To: <A.Lewis-Nunes@maxfordham.com>
Subject: RE: Grenfell - Actions from M&E meeting

Boxing Bag Support

Floor

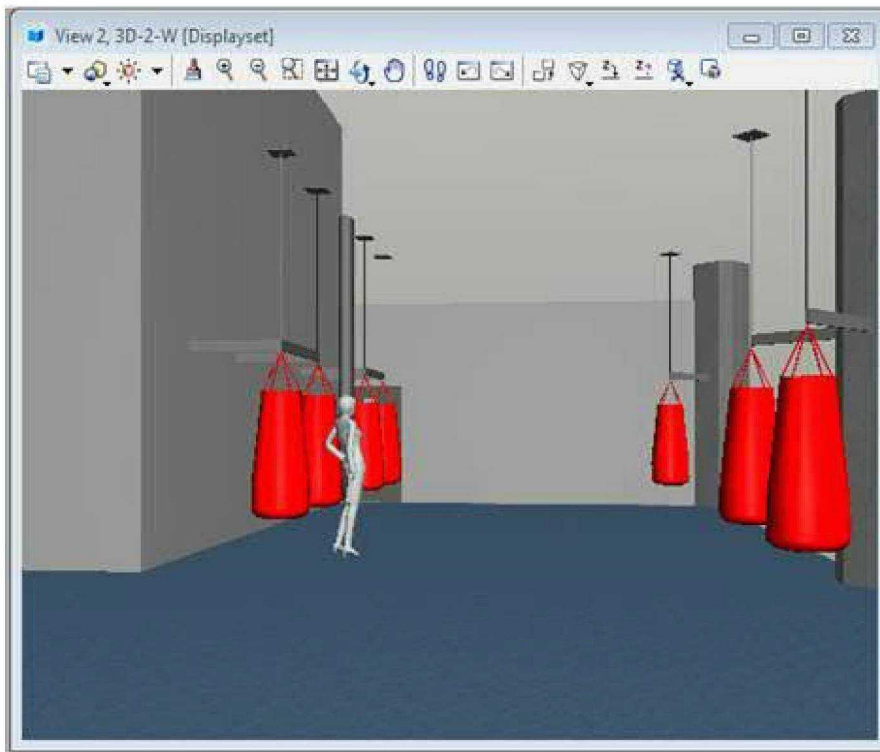
We're proposing to show the bags, dotted, as below.

My issue is that we are not supplying the fixings, nor are we yet clear on the numbers of punch-bags etc. If we need to specify a type of fixing, then we will need to do this via the lease; which means the boxing club need to be fully alerted to this. Will the testing tell us if there is a preferred type of fixing for the punch bags?
